ADDENDA N° 3

IN RESPONSE TO THE 3RD REPORT CONSOLIDATED REQUEST FOR
CLARIFICATIONS, CORRECTIONS AND/OR ADDITIONS OF THE
ENVIRONMENTAL IMPACT STUDY

“ESPEJO DE TARAPACÁ” PROJECT

October 2015

Figure 2-1 location of additional piezometers in sector Costa - San Marcos

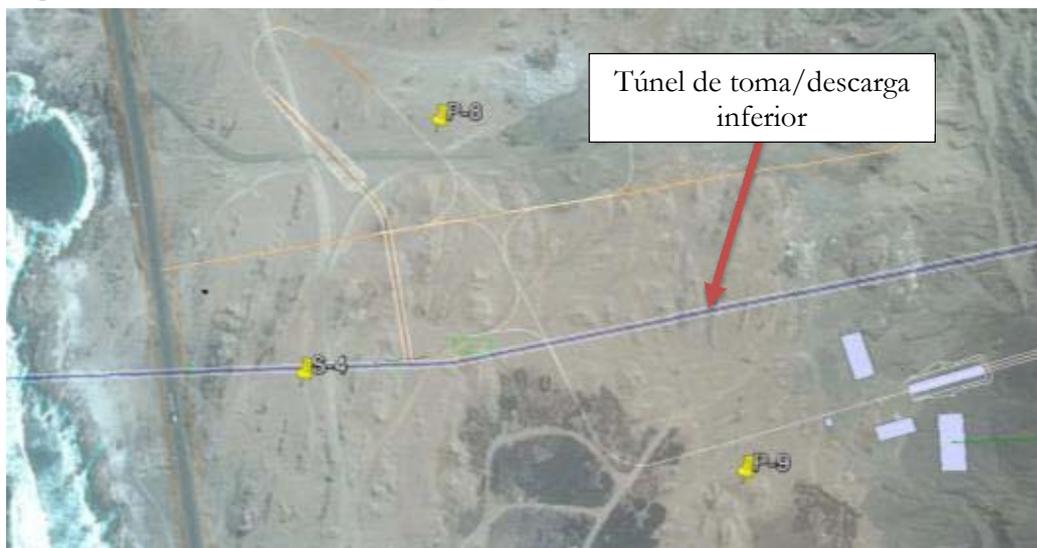
Given the above, it is the holder must take into consideration that low (Cliff and coastal sector) project for the area, the area of influence will be a RADIUS or distance of at least 200 metres, with respect to the underground tunnel. In this sense and without prejudice to that product's evaluated history, been ruled out the generation of significant impacts from the project, it is necessary that will safeguard the hydrogeological component, through the monitoring of the quality and quantity of the waters in the coastal sector and Cliff. The characteristics of this monitoring, are the exposed observation 8.2 of this report.

This monitoring will measure pH, conductivity, temperature and level piezometer at the point of probing S-4 as well as two new points of monitoring additional located in the area of influence of the underground tunnel, as described in 8.3 response. Below is indicates the area where intends to install the additional piezometers P-8 and P-9 in the sector of the lower tunnel.

Reference coordinates are presented in the following table.

Figure 3-1 Location of witnesses (drilling) drilling

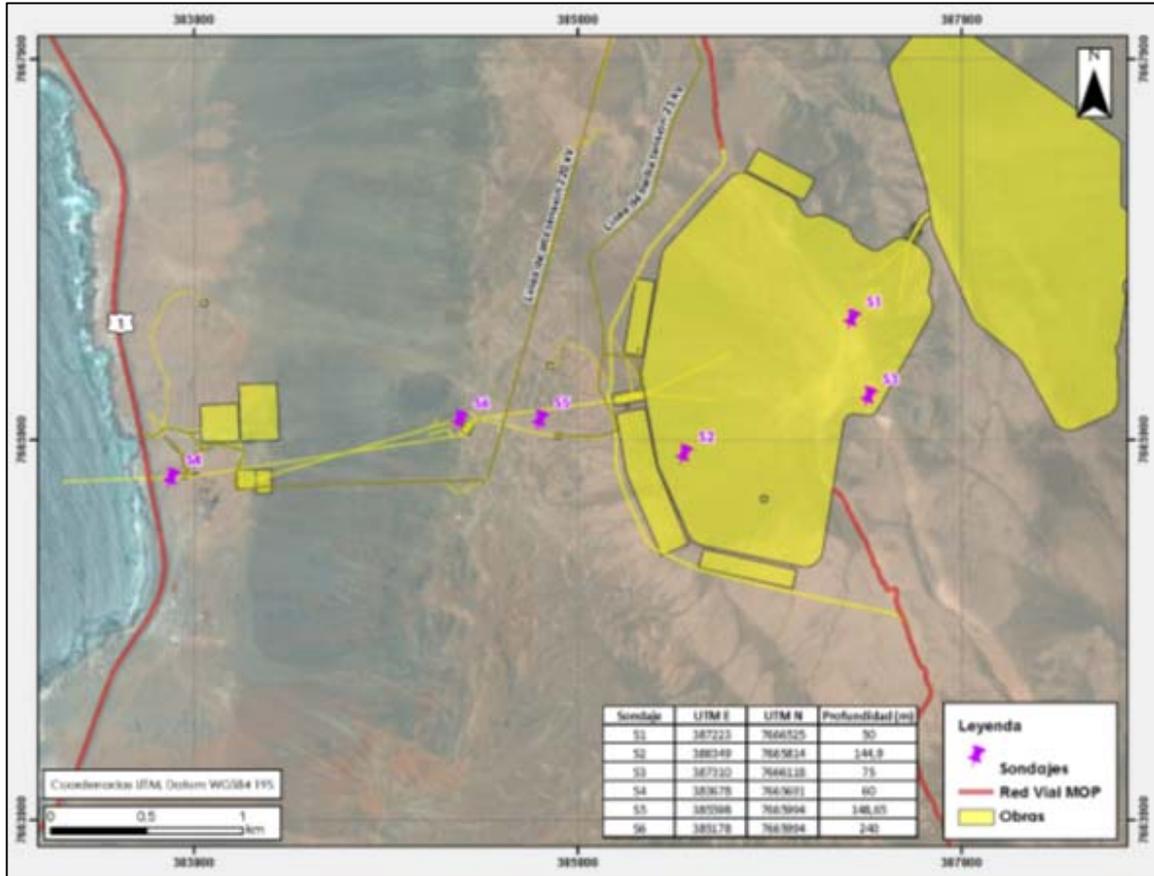
- 3.1. With respect to the revision of the geologic drilling required S2 and S3 in order to detect or rule out the presence of paleontological material in the Area of influence of the project, in point 3.10 of the addendum N ° 2, the holder informs that you for the sectors of "drillhole S1 to S3 are located in areas of the project where the works or underground activities will not develop and therefore, it will not affect subsurface.". However, it is the description of the geological content of the same. Therefore reiterates the holder that is they must submit all the history associated with the drilling S2 and S3, which should be reviewed in this instance with the criteria previously requested by the competent authority, through its Ord ex officio. CMN # 4155 in the 14.11.2014. The above, since, without prejudice that these were not carried out in the areas where they would be running underground works, is not clear if the drilling carried out affected or not geological units that, by lateral continuity, yes could correspond to units which contain remains paleontological will be affected by excavations in other parts of the work.**

As for the drilling madethe Figure 3-1 Redisplays its location together with the works of project (Figure 3-5 of the addendum to supplemental (second addendum)).

In addition, in the Figure 3-1 shown that drillhole S2 and S3 are located in areas of the reservoir of the project where works or underground activities will not develop and, therefore, it will not affect subsurface. Probing S2 was approximately 450 m from the portal of the tunnel top heading south-southeast home. On the other hand probing S3 was approximately 1,300 m from the portal of tunnel top heading West home.

Figure 6-5 Aerial view of the foundations of the lift (VE-31)

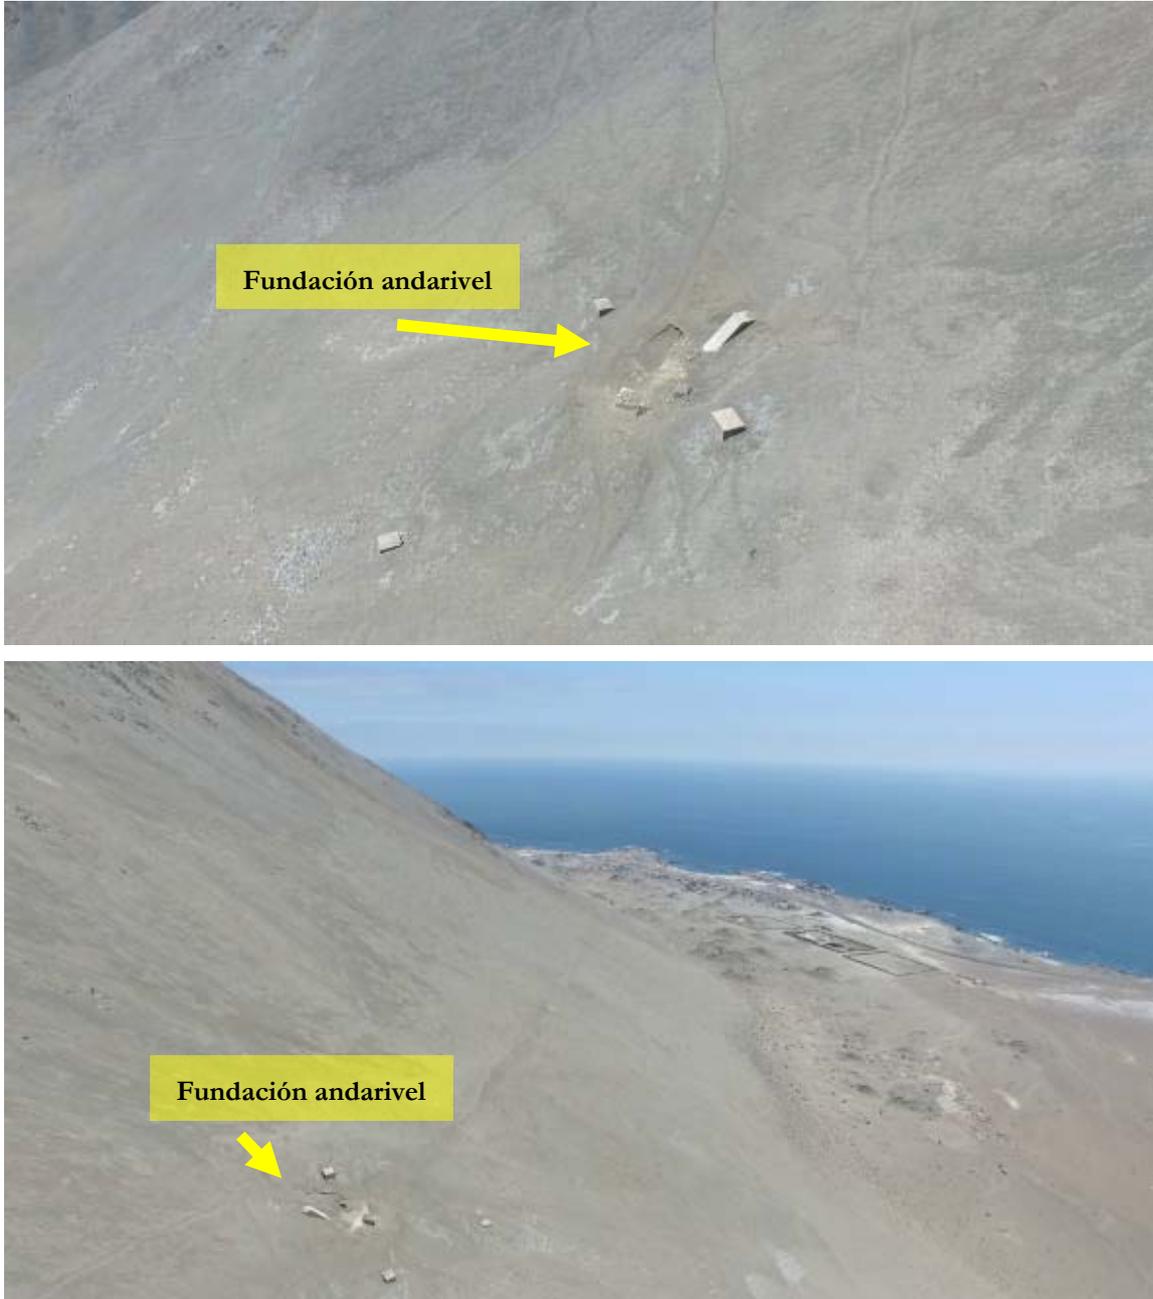
6.5.3. With respect to sites 31-VE and VE-32 corresponding to a lifeline and a salt, respectively, indicated the holder that the authority was in accordance with the fence with wire mesh. However, in the addendum N° 2 is suggested fencing by clasp in the areas closest to these sites, in order to divert traffic. Therefore, the holder shall provide all background information allowing to assess this new measure, for what must deliver one photography satellite with the path of the nearest work and the location of these square brackets; Ideally a picture generates both sites with works and one in detail.

On the other hand, el change in the form of implementation of the action described in the present question is fully justified Therefore, in the case of the VE-31 site, the foundations of the lift are in a sector with a steep slope, where could hardly move vehicles, since the place has little accessibility (see Figure 6-4 and Figure 6-5). In addition It has been estimated that the extent of the fencing in the terms initially requested by the CMN may backfire and unfit for precautionary measures the real goals that underlie its implementation, as could increase the vulnerability of the site that you want to protect to make it more visible, attracting Consequentially people to be directed to it.
